**APRIL 6, 2017**  
**BOARD OF COUNTY COMMISSIONERS**  
**ORANGE COUNTY, FLORIDA**  
**ADDENDUM NO. 2 / IFB Y17-744-CC**  
**ORANGE COUNTY FIRE RESCUE-STATIONS VEHICLE EXHAUST**  
**REMOVAL SYSTEM**

**Orange County  
Fire Rescue Exhaust Removal System**

**FIRE STATIONS 40  
HVAC PLAN**

DRAWING NO. SA-WD-VTK-2

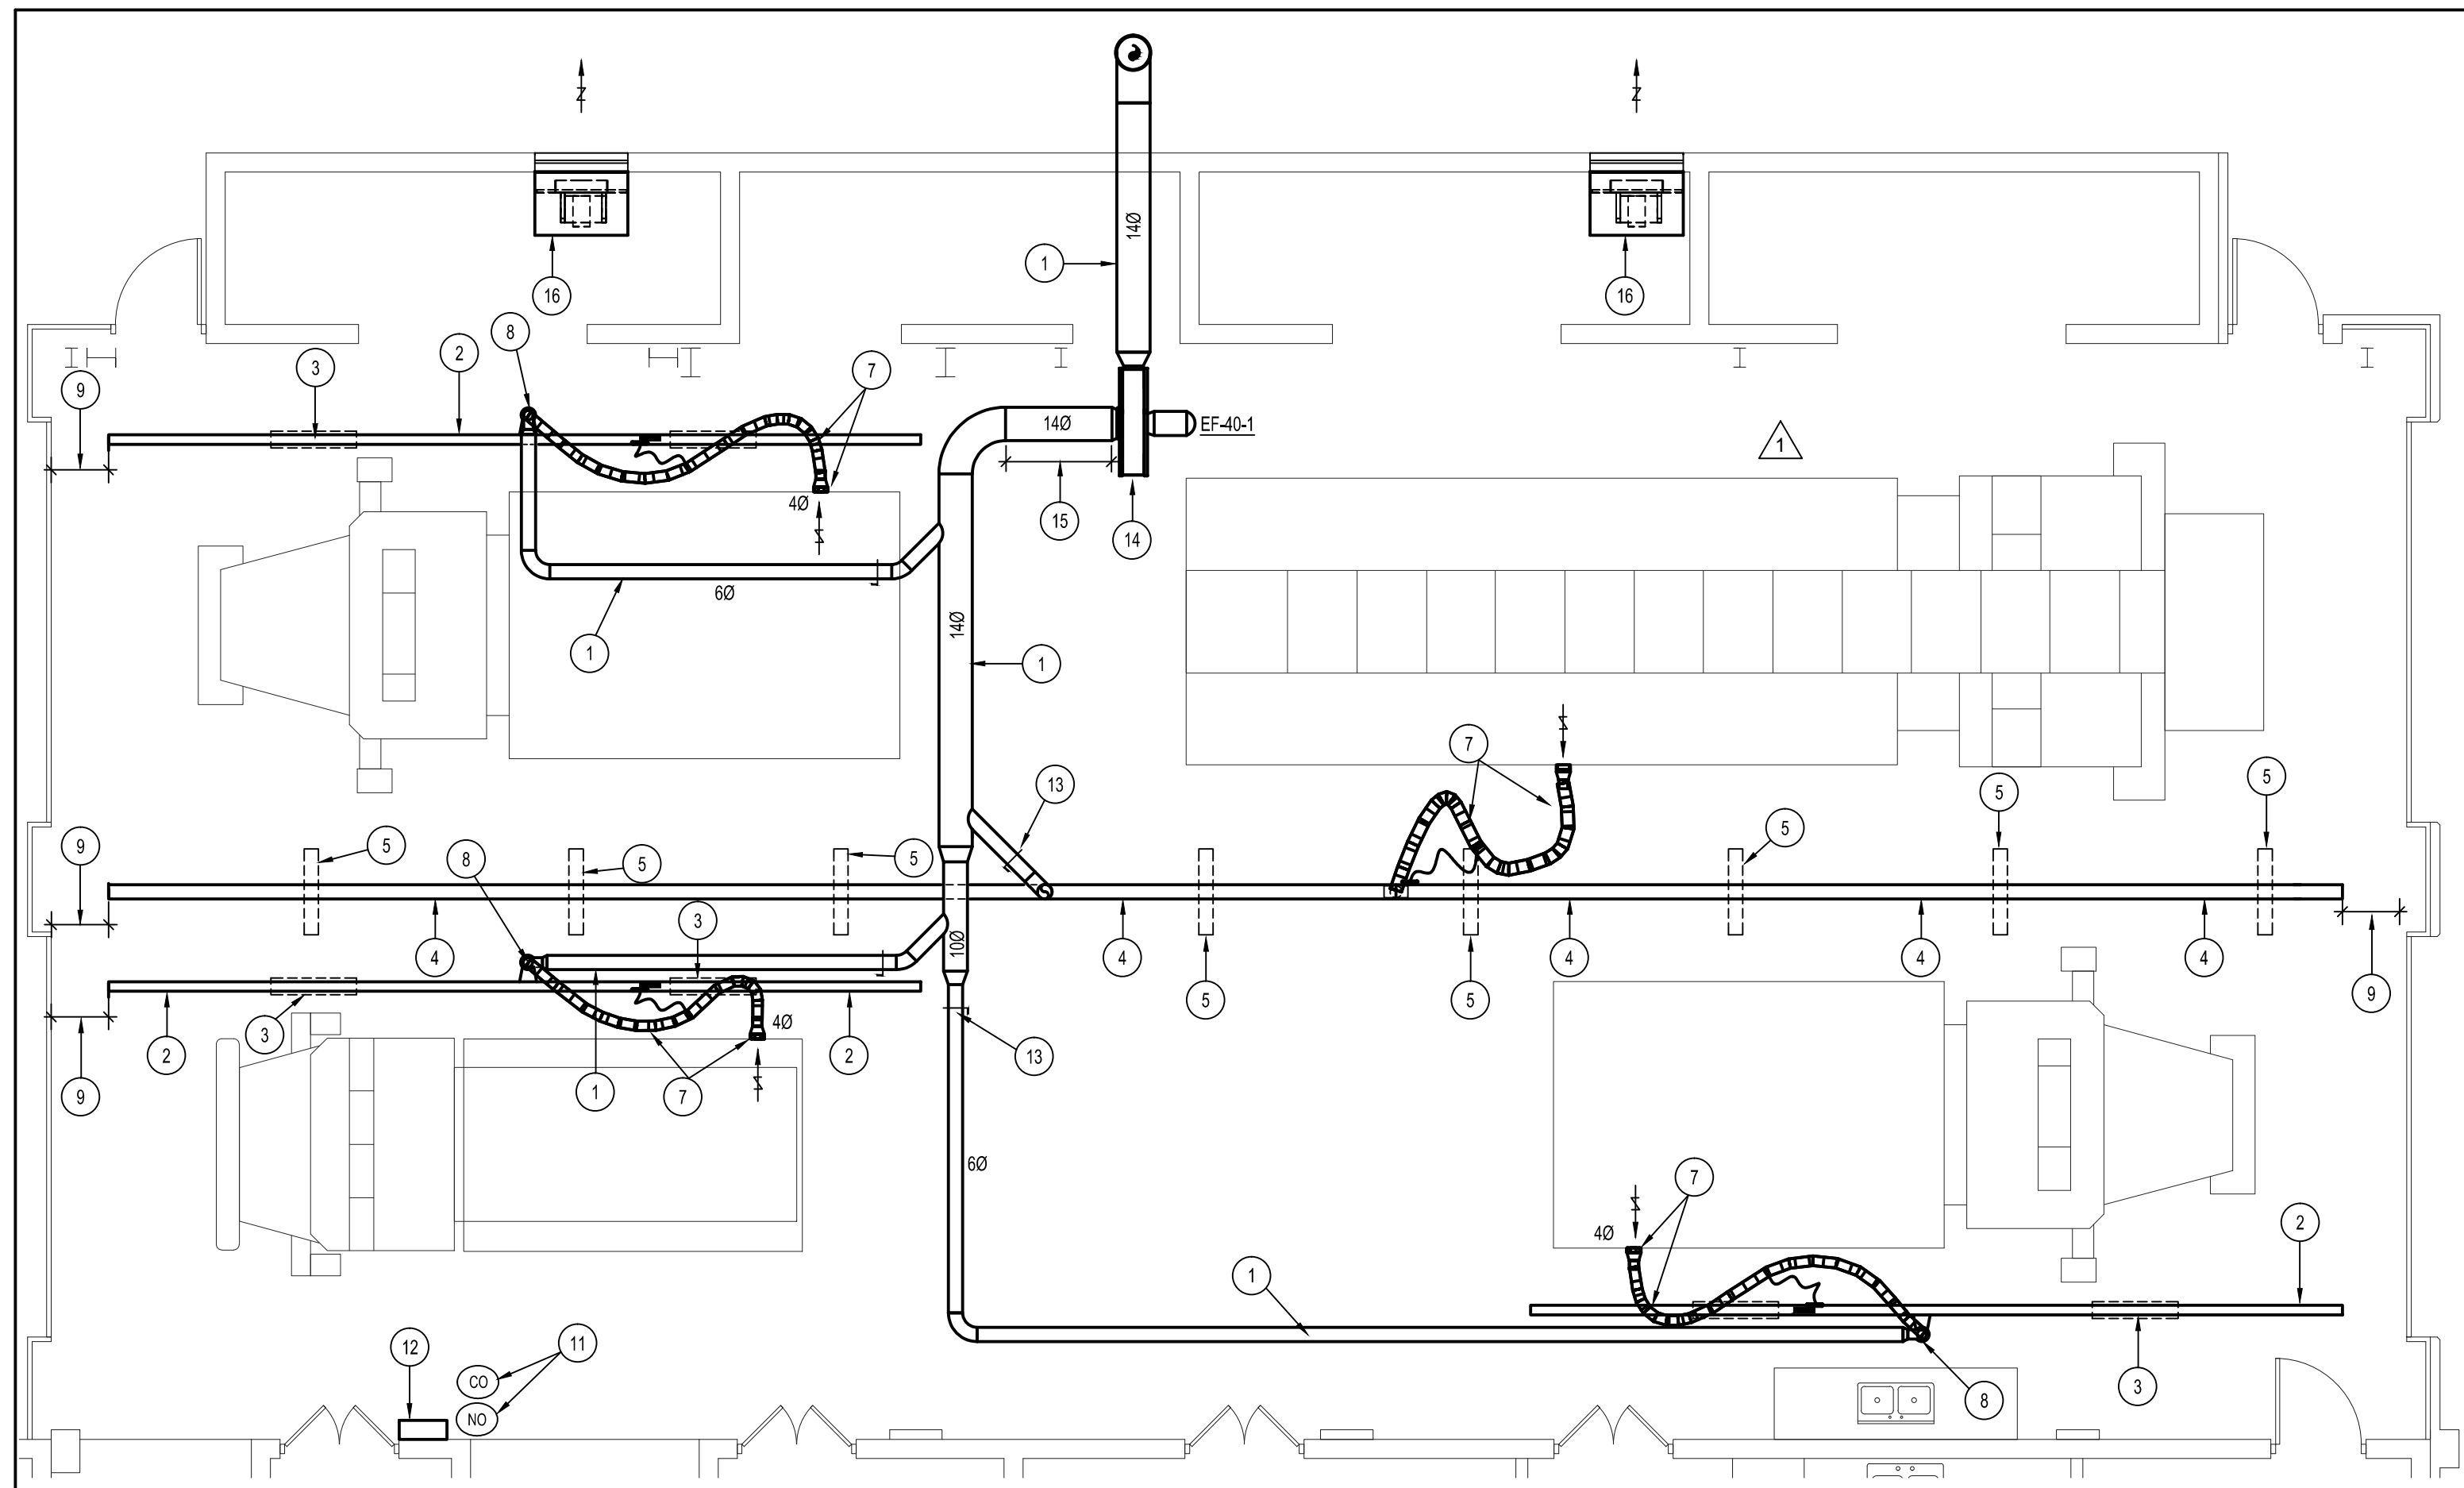
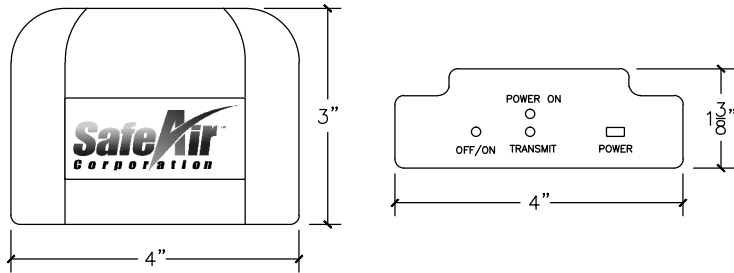
**3. Question:** The drawings for this project refer to on-board ignition starts however the specifications give no direction as to the starting mechanism for the vehicle exhaust system fans. Since there is no direction in the written specifications that I found as to the starting mechanism for the vehicle exhaust system other than the safe Air electrical diagram at the bottom left of the mechanical drawings, are pressure sensors in the ductwork with transmitters an acceptable starting method instead of the on-board ignition transmitter start method? On-board ignition starts on the type shown on the drawings can sometimes cause interference with other electrical transmissions such as overhead door transmissions, etc.

**Answer:** Pressure sensors with transmitters are not acceptable. Provide vehicle RF transmitter as shown on diagram and explained in the sequence of operation in design documents. Basis of Design: Safe Air USB Vehicle Transmitter Kit SA-WD-VTK-2 or equivalent. (See attached Submittal Sheet for reference).

**M-140**

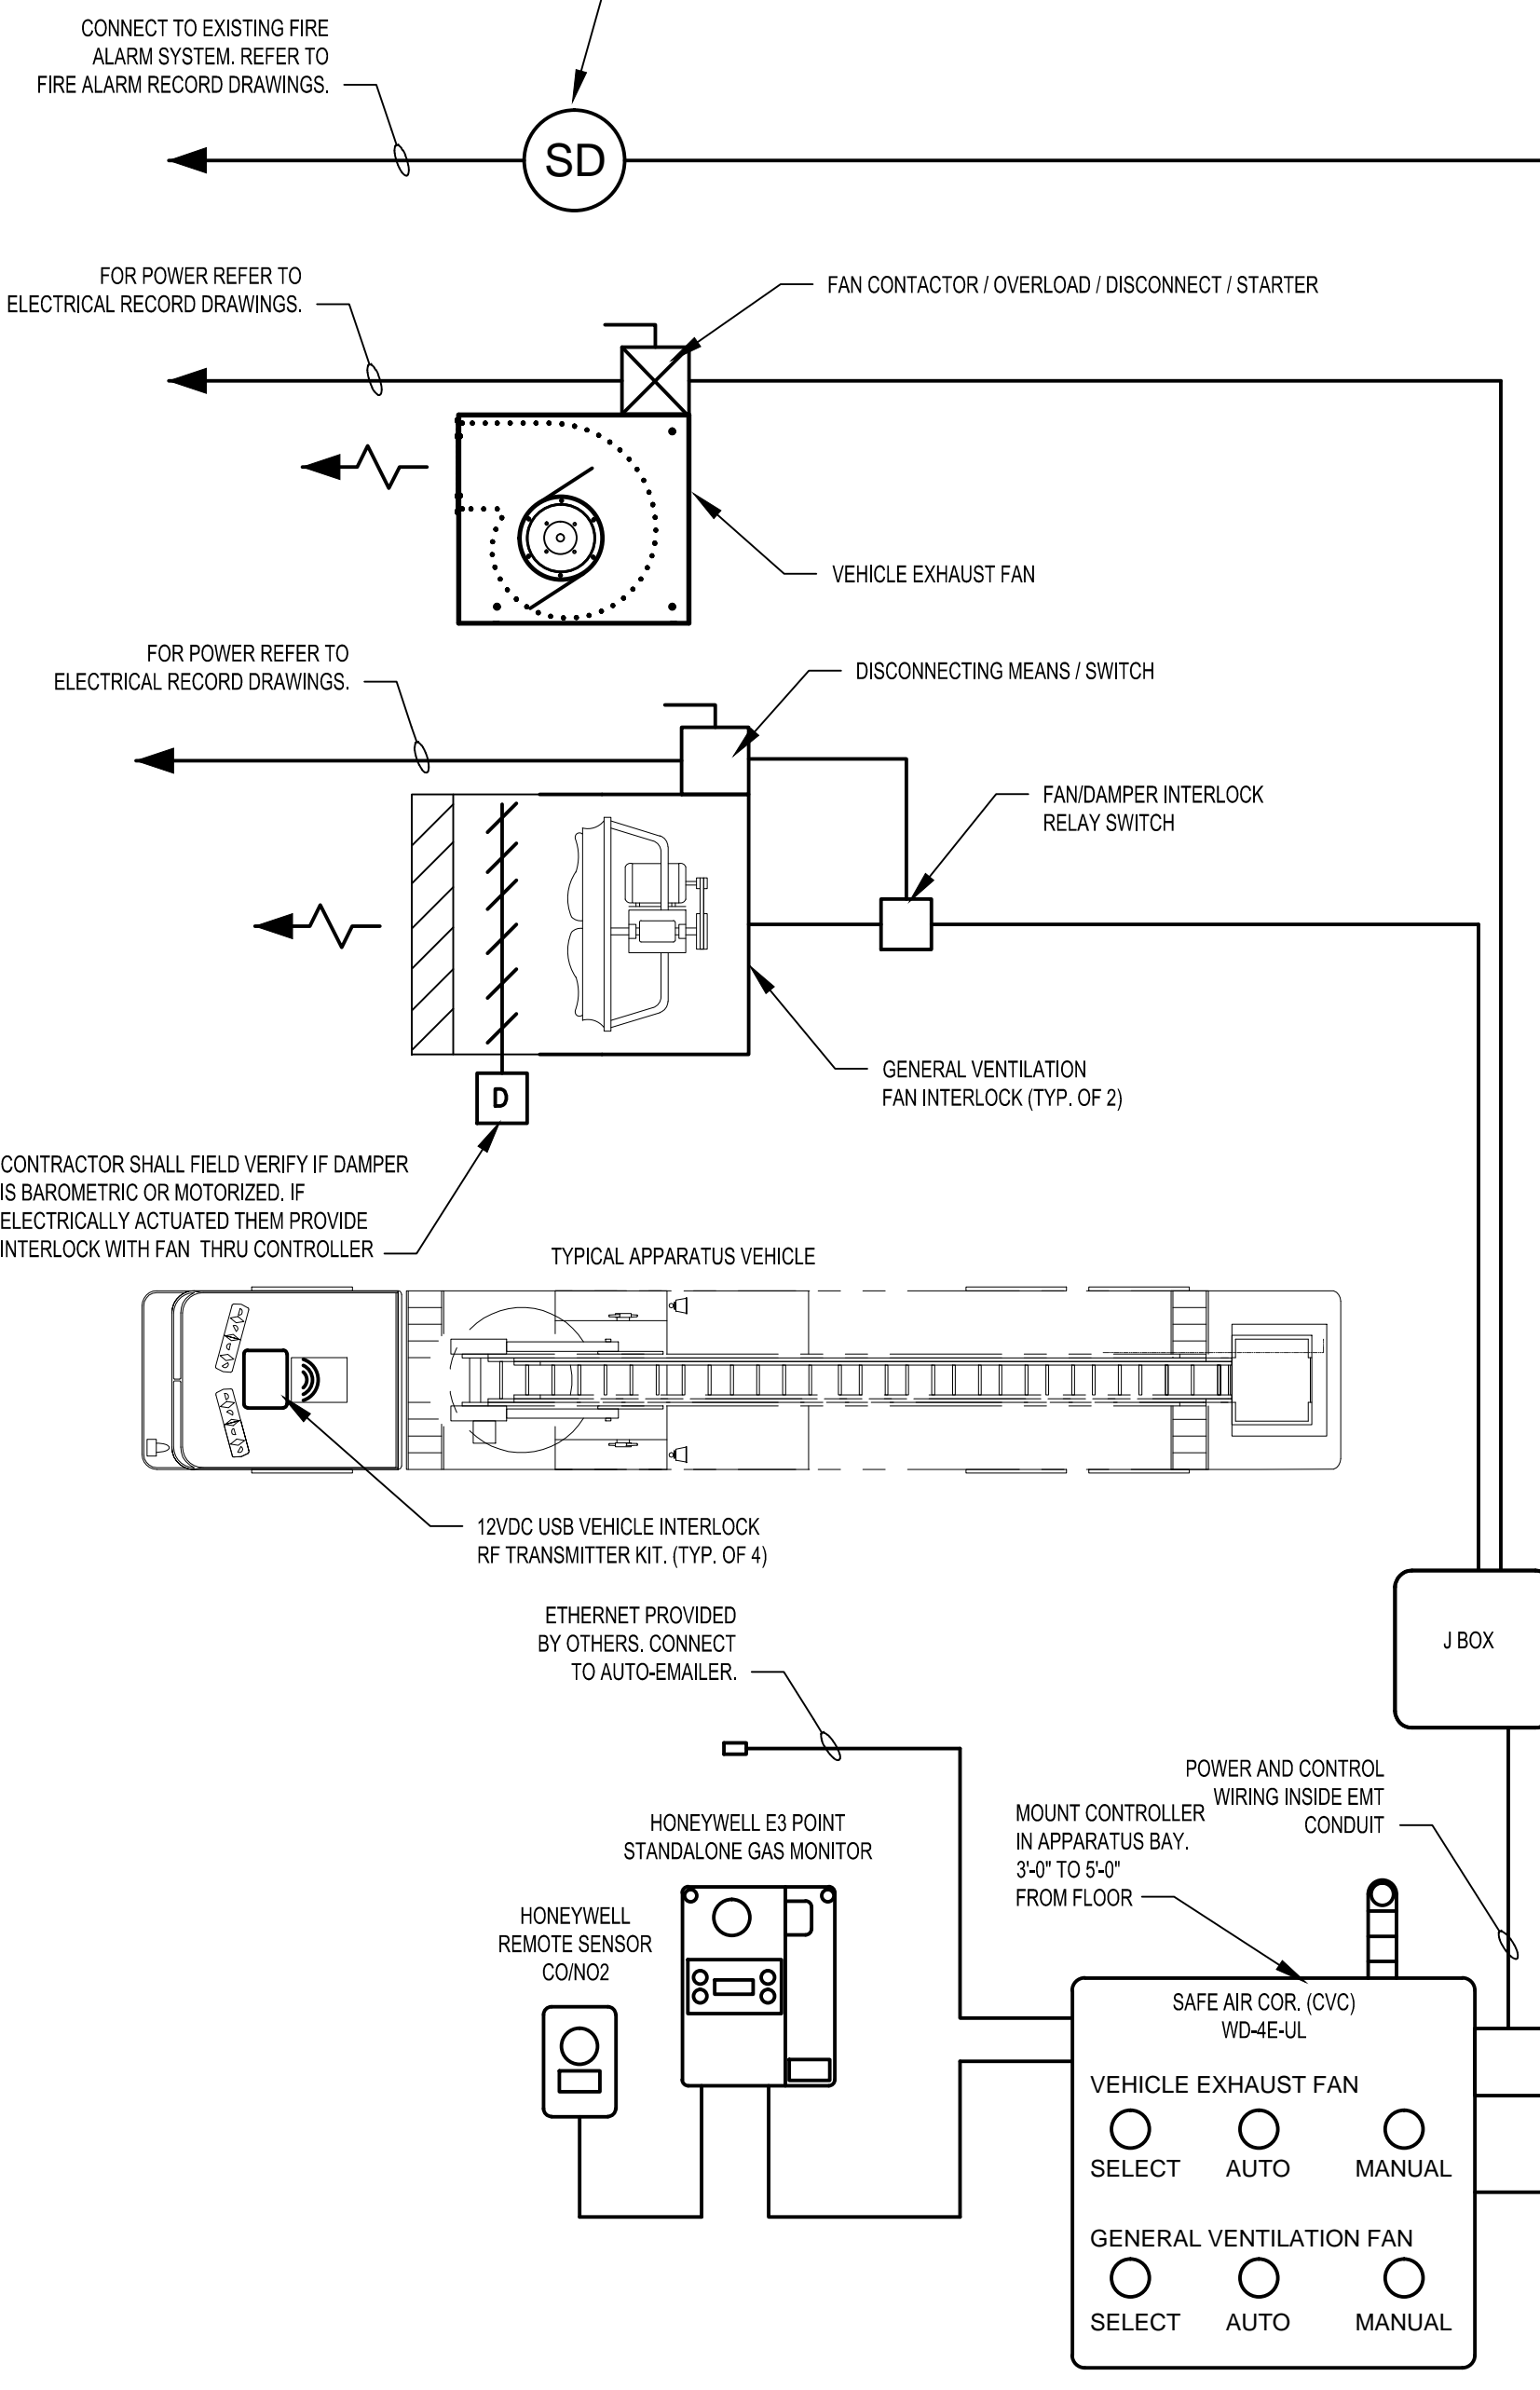
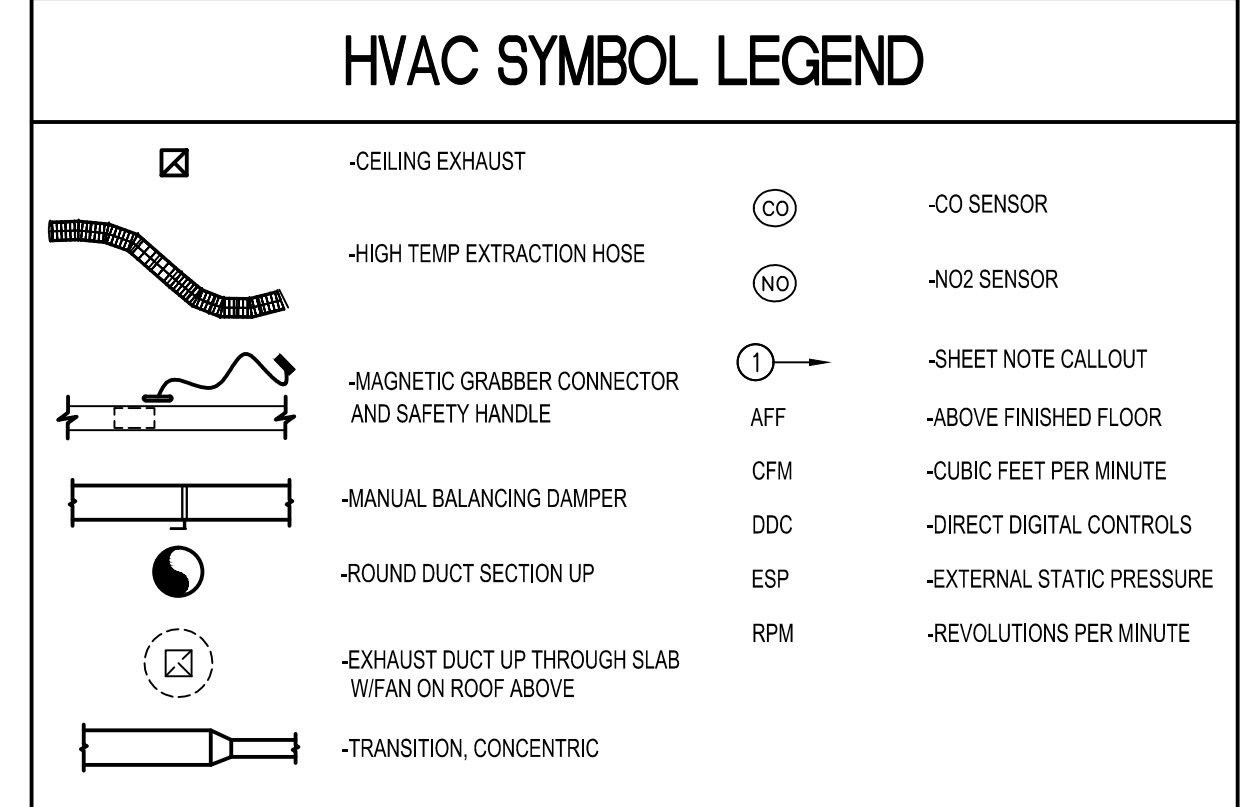
**6. Question:** When the number of tracks or suction rails on the drawings vary from the scheduled listing of tracks or rails, does the drawing take precedence? Should we quote the number of tracks and hose drops shown in the drawings instead of what the schedule describes on the listing? Example, Station 40's listing describes 2 sliding balancer track systems with one drop each and 1 suction rail system with one drop on the schedule for a total of 3 tracks or rails and 3 hose drops but show 3 sliding balancer track systems and 1 suction rail system on the drawing for a total of 4 hose drops.

**Answer:** This discrepancy noted only occurs for Fire Station 40. Please refer to the attached revised Sheet M-140.
